**MASTER DEVELOPMENT DRAINAGE PLAN
AMENDMENT AND
PRELIMINARY DRAINAGE REPORT
FOR
FOREST LAKES (PHASE 2)
EL PASO COUNTY, COLORADO**

November 2018

Add PCD File No. PUDSP181

SOILS MAP (S.C.S. SURVEY)

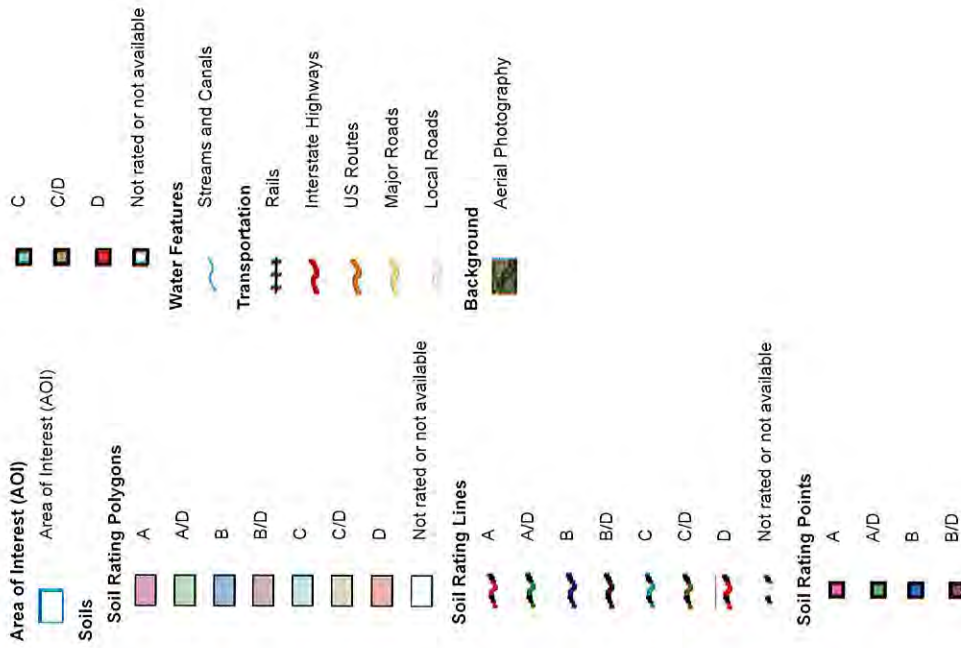
Draw the Phase 2 boundary for clarity. Initial glance of the Area of Interest leads readers to assume the site is located in the Soil Type D to the west.

Project: **FOREST LAKES PHASE 2**
 Basin ID: **DP-6 - MESA TOP ROAD CROSSING OF NORTH BEAVER CREEK**

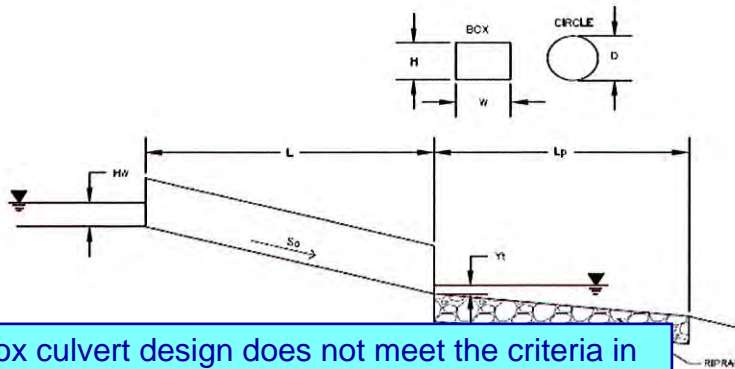
FYI: A simple culvert analysis does not seem to be the appropriate method for analyzing the bridge. North Beaver Creek with the bridge structure should be modeled/analyzed with HEC-RAS.

This box culvert design does not meet the criteria in DCM Chapter 6 Section 6.4.2 which requires two feet of freeboard between the box culvert ceiling and the 100yr WSE. Revise.

Detention Basin Outlet Structure Design

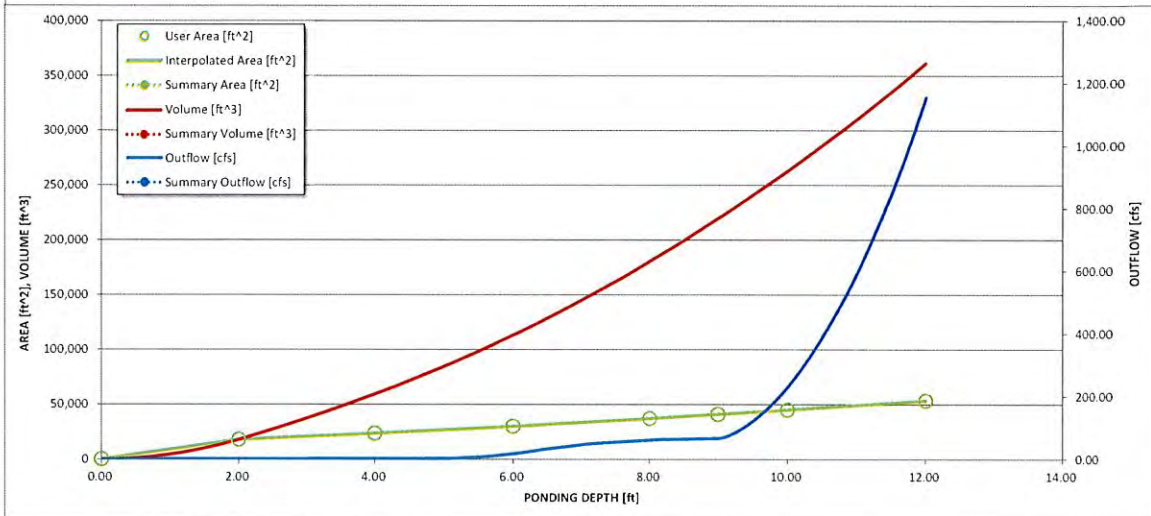
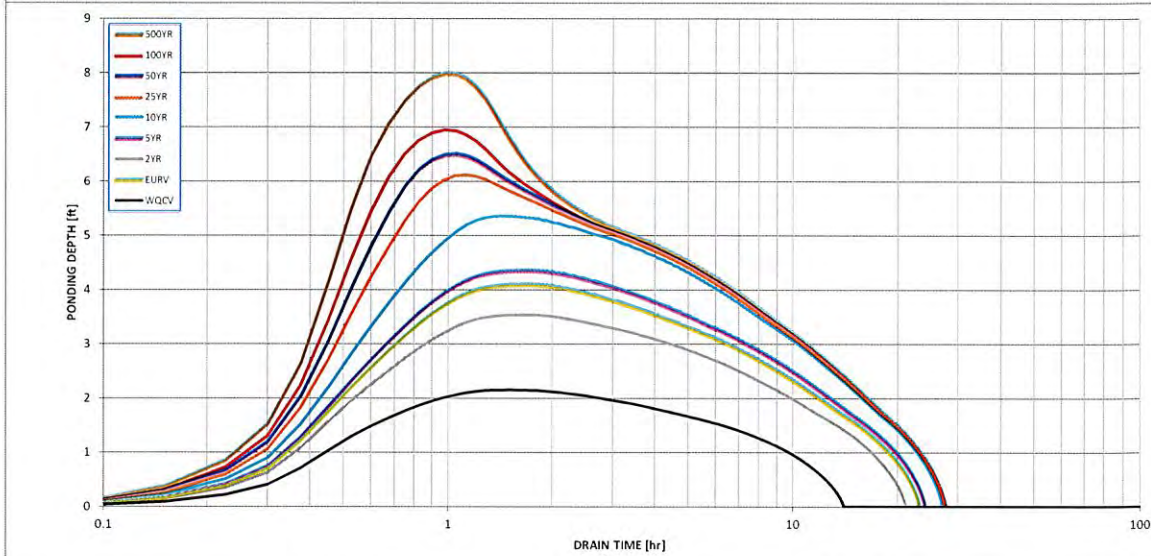
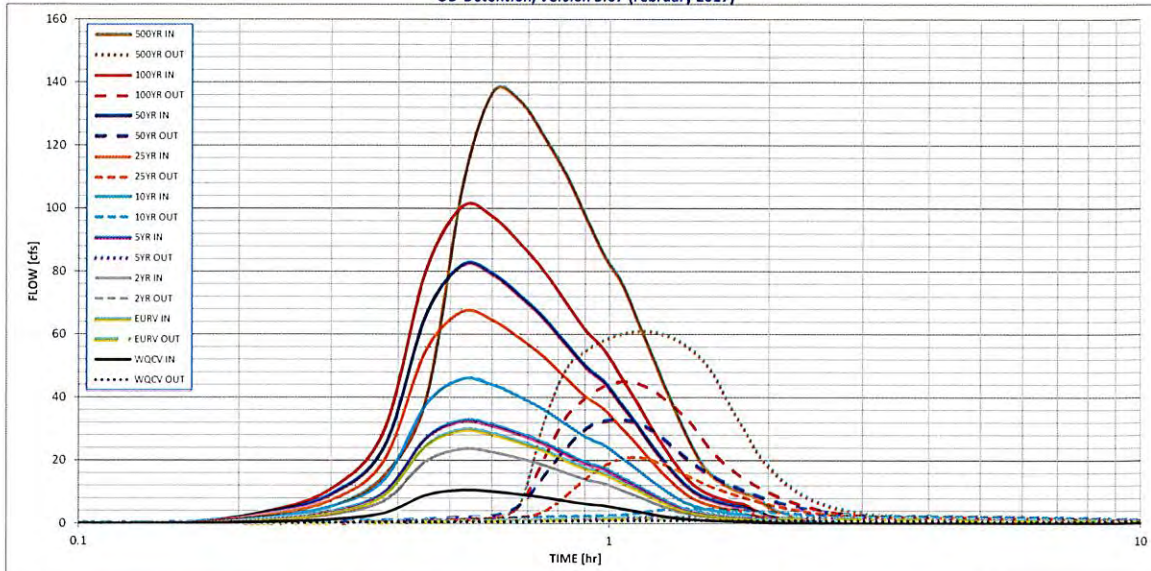
FYI: Outlet structure will need to be revised on the FDR to release the 5yr at or below historic.

Detention Basin Outlet Structure Design

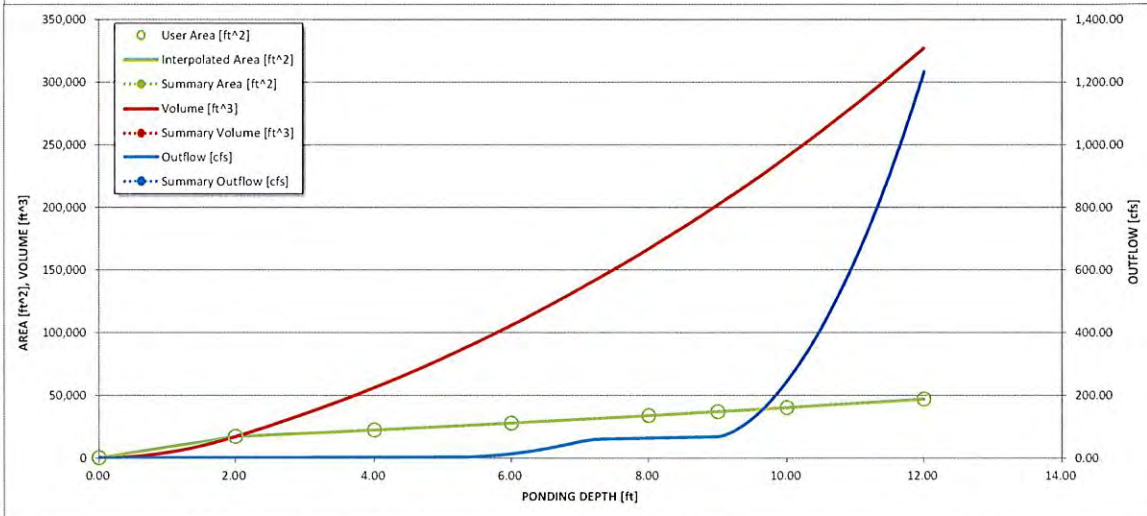
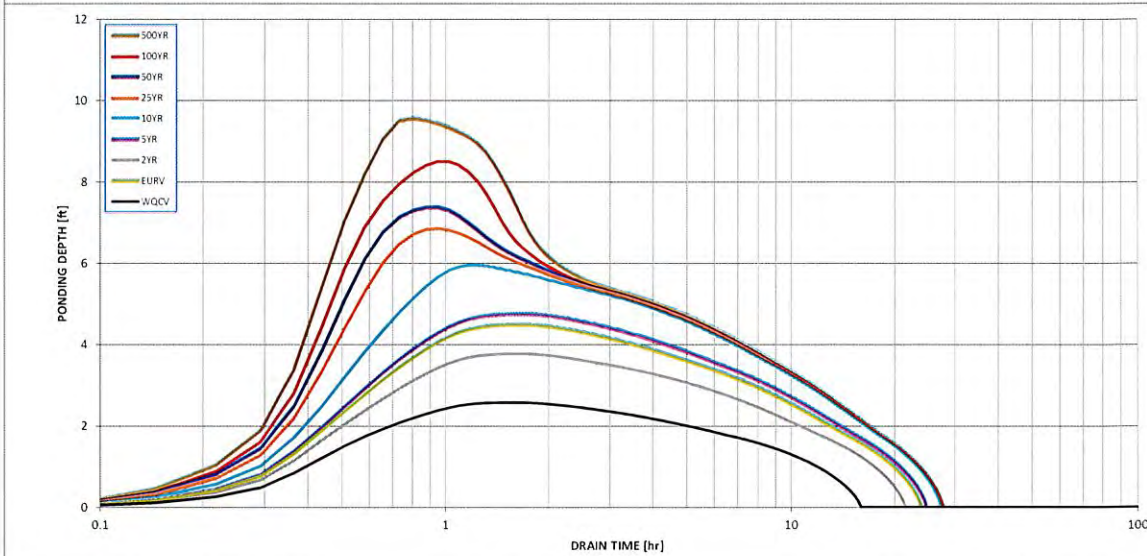
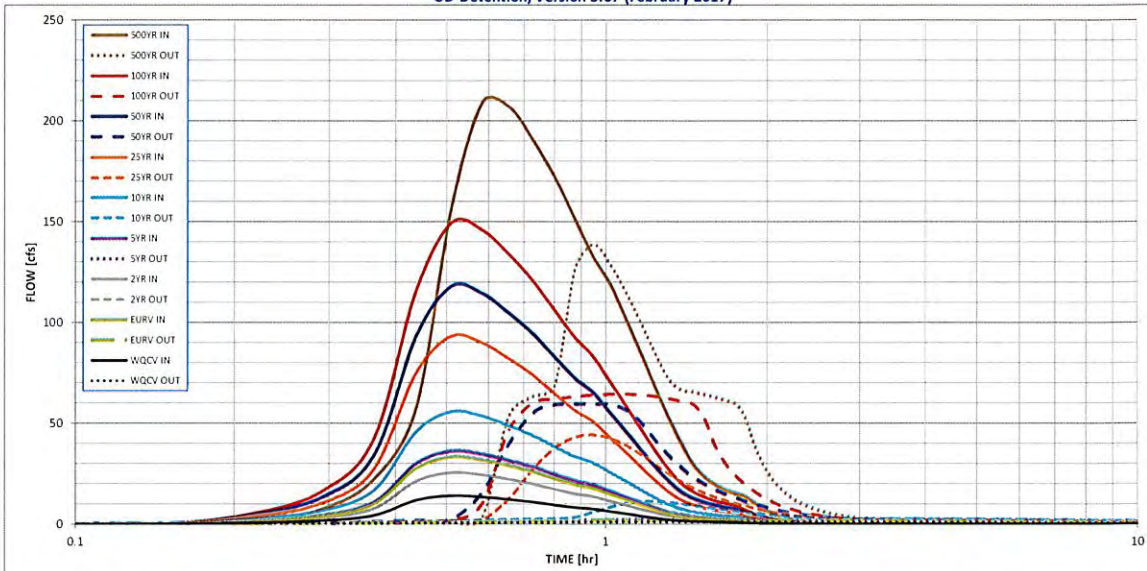
See comments on Pond A worksheet

Detention Basin Outlet Structure Design

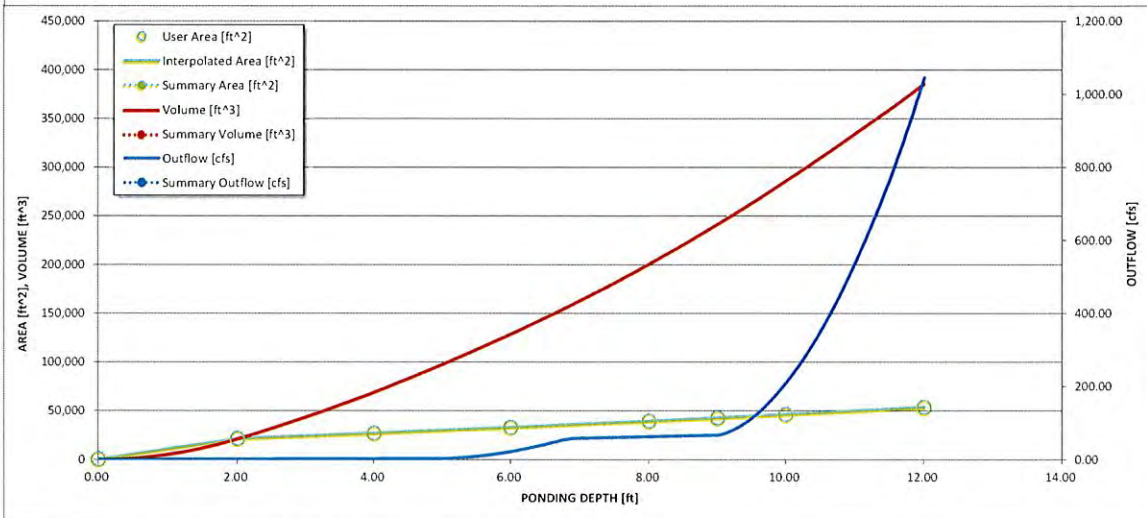
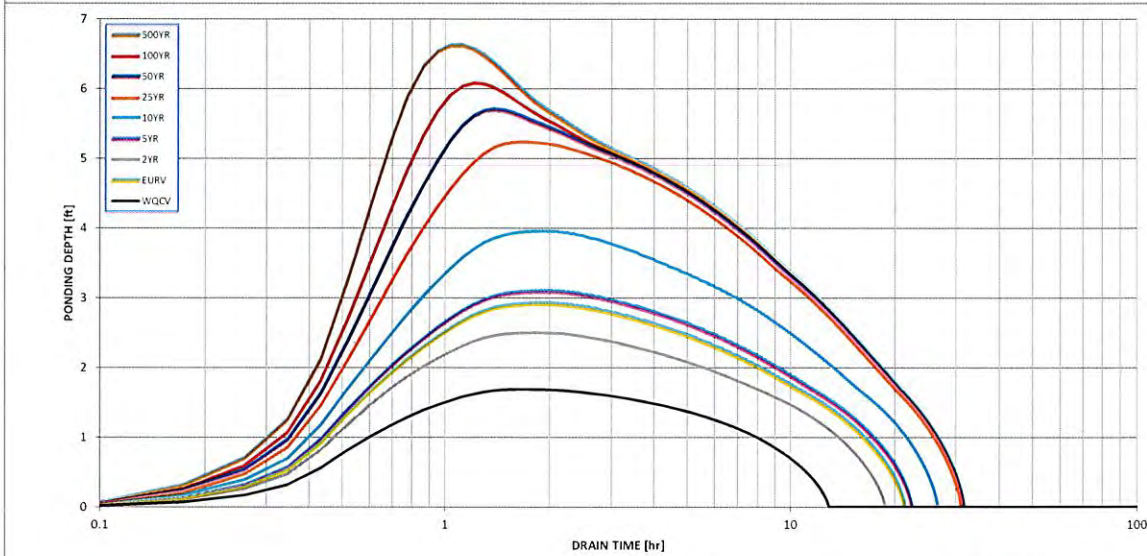
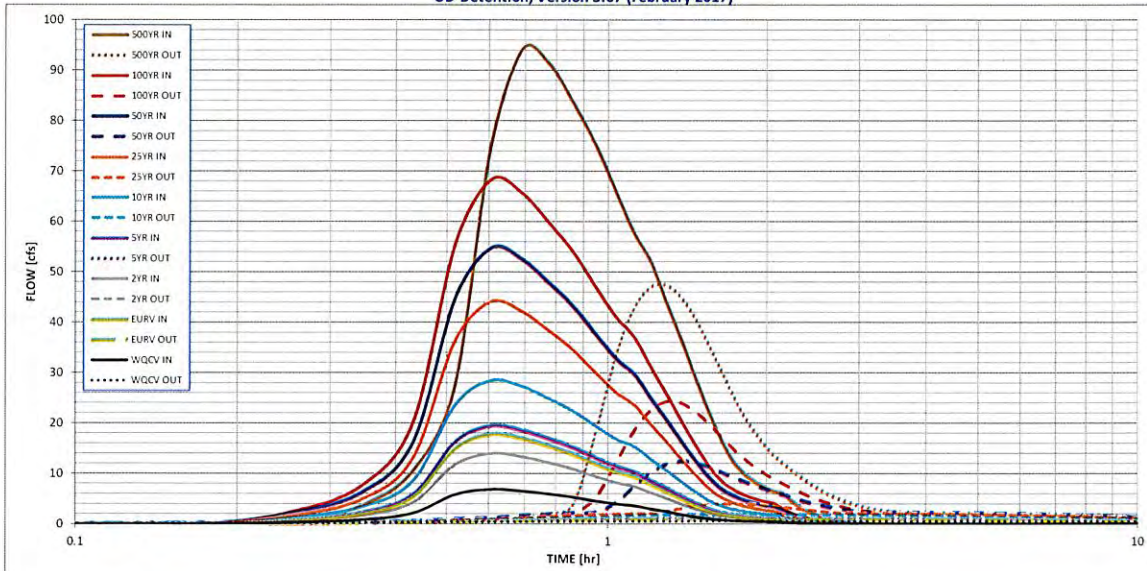
See comments on Pond A worksheet

FOREST LAKES PHASE 2
MDDP AMENDMENT &
PRELIMINARY DRAINAGE REPORT
DEVELOPED CONDITIONS

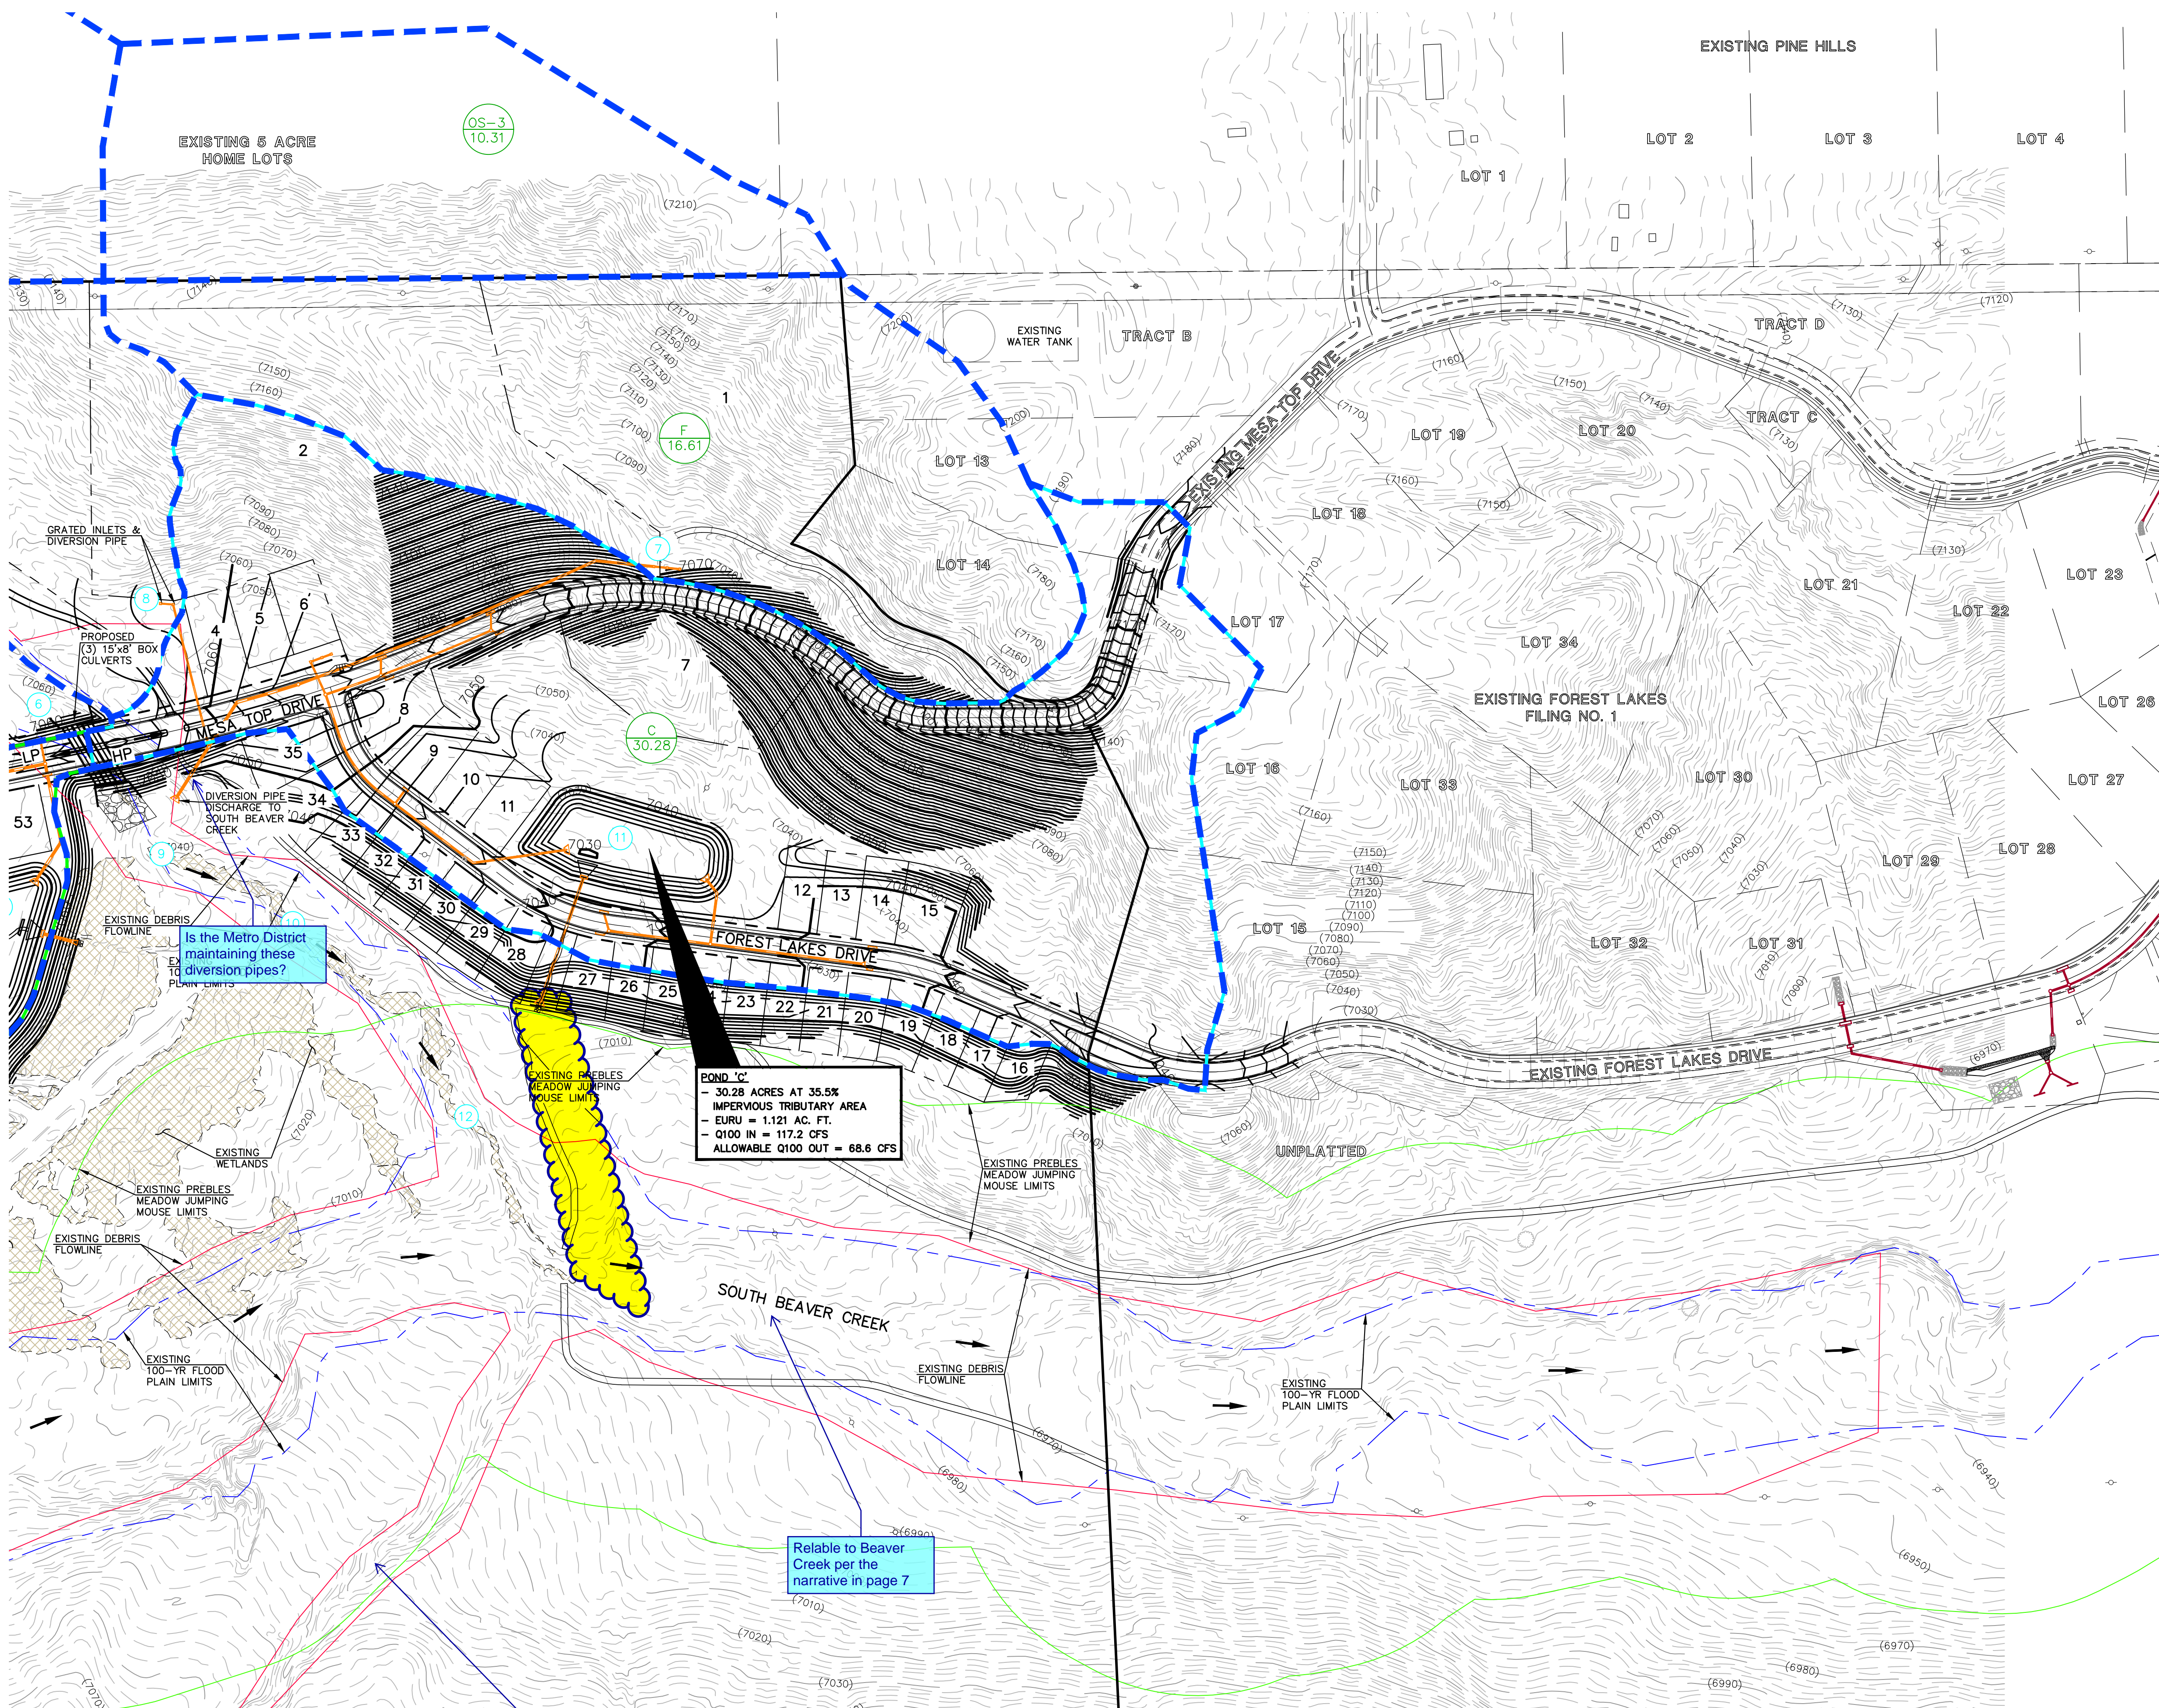
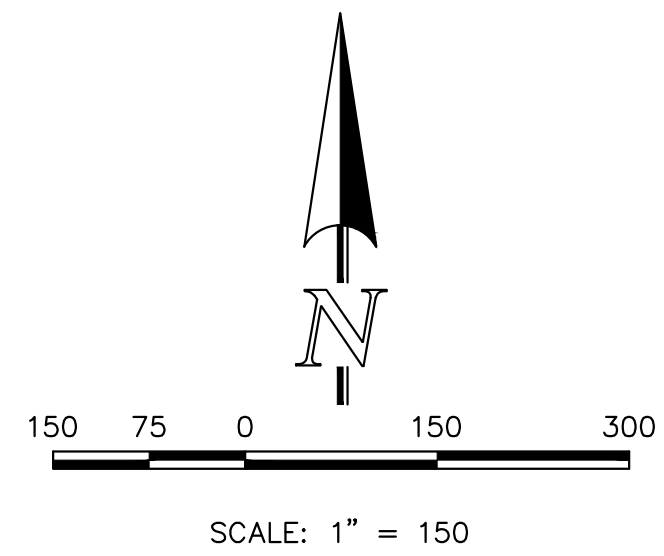
Show/label how sheet flow will be routed into the grated inlets. Will there be grass swales along the top of the 3:1 slope?

Based on the proposed contours there's no cross slopes from the toe of the 3:1 towards the road at the areas highlighted in yellow. The toe of the hill would behave as a swale conveying drainage across lots.
- If this is the intent then drainage easement and swales across lots must be shown on the preliminary grading plan
- If the intent is to provide side lot swales then provide a typical detail in the preliminary grading.

Show the emergency overflow path for these diversion inlets.

The segments between the outfall and the existing channel must be hydraulically adequate. Additional improvements may be required. (See areas clouded in yellow)
Add a note that the FDR will provide hydraulic analysis from the discharge point to the creek.
